SUBJECT: RIVER BEND STATION, UNIT 1 - ISSUANCE OF AMENDMENT RE: INCREASE
IN MAXIMUM ALLOWABLE THERMAL POWER TO 3039 MEGAWATTS
THERMAL (TAC NO. MA6185)

The amendment changes the FOL and the TSs to allow an increase in the maximum, allowable thermal power from 2894 megawatts thermal (MWt) to 3039 MWt.

Figure 3.4.11-1 (page 1 of 1)
Minimum Temperature Required vs. RCS Pressure

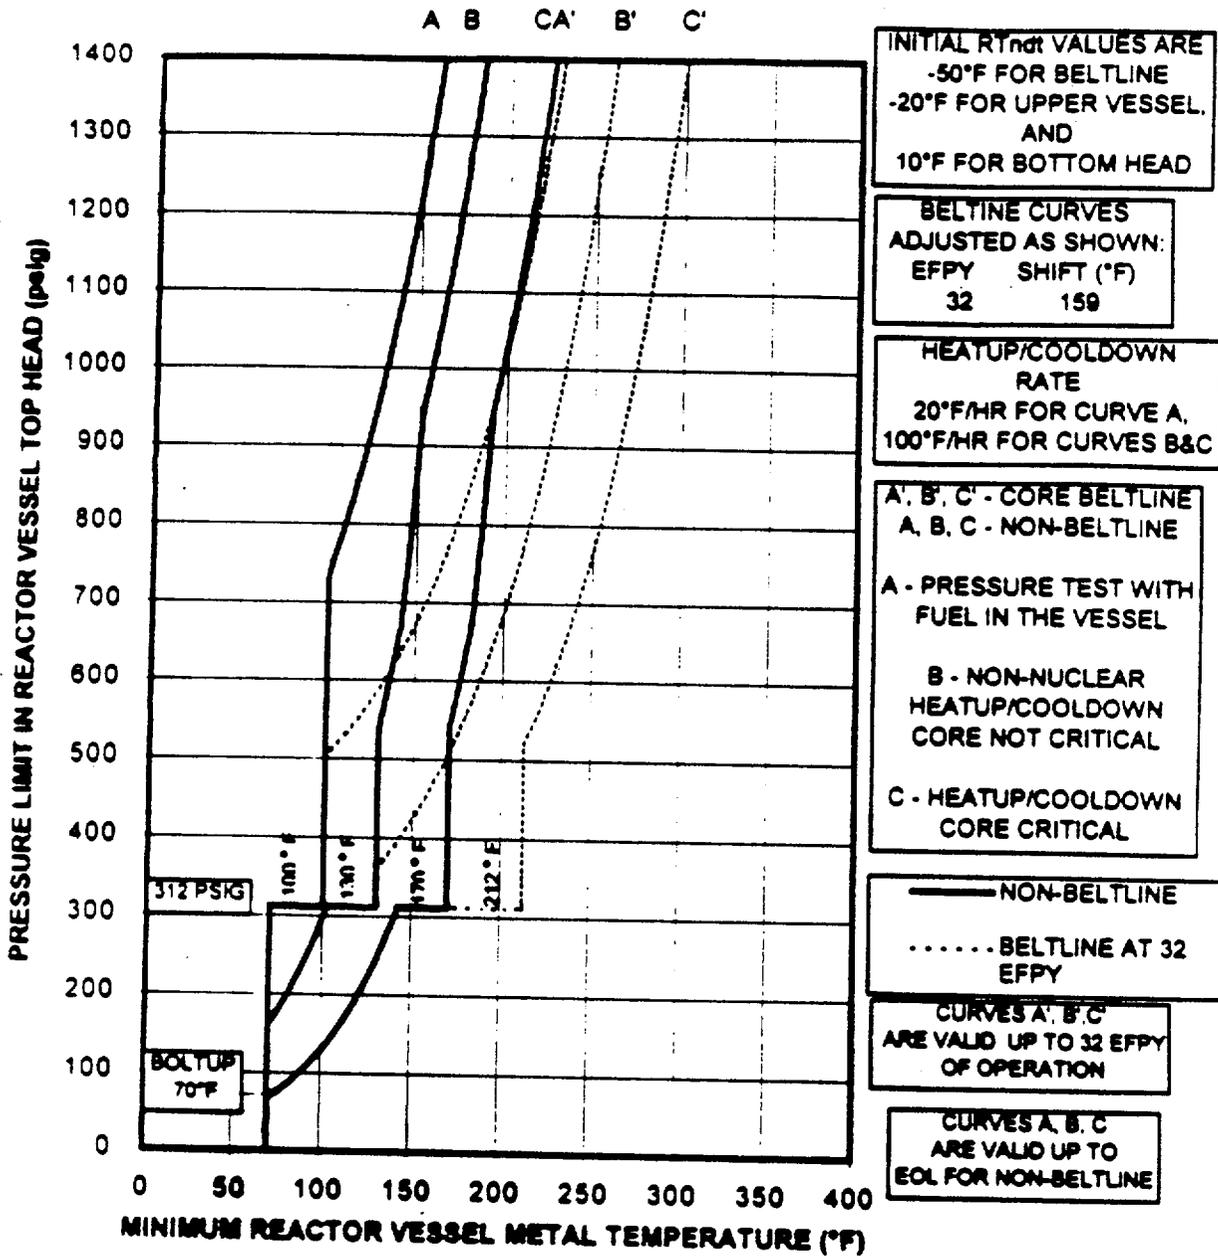
14. RCS P/T Limits, TS Figure 3.4.11-1 and SR 3.4.11-1

As noted in Section 3.2.3 herein, the licensee has proposed the adoption of 32 EFPY P/T limits. This proposal involves the replacement of TS Figure 3.4.11-1 and associated changes to SR 3.4.11.1 and SR 3.4.11.2, "RCS Pressure and Temperature (P/T) Limits." As noted in Section 3.2.3 herein, adoption of the 32 EFPY P/T limits is acceptable; accordingly, these proposed TS changes are acceptable.

The NRC staff approves the use of the P-T limit curves (designated as "32 EFPY" curves) through 16 EFPY of operation. For continued operation beyond 16 EFPY, additional information to address staff concerns regarding the RBS fluence calculations must be provided or an amendment to the P-T limit curves submitted. By letter dated May 8, 2000, EOI committed to use the "32 EFPY" curves in the power uprate request until the test results from the first RBS surveillance capsule were acquired and EOI received NRC approval to implement revised P-T limit curves based on this information. In accordance with the current RBS RPV surveillance capsule program, this information will be submitted to the NRC staff, as required by the reporting requirements of 10 CFR Part 50, Appendix H, with sufficient time for NRC staff review and action before the RBS RPV exceeds 16 EFPY of operation. Should EOI request NRC staff approval to modify the RBS RPV surveillance program, EOI should address how these modifications will affect their ability to meet the commitment in their May 8, 2000, letter and address how continued operation of the RBS RPV will be demonstrated in light of the surveillance program modifications.
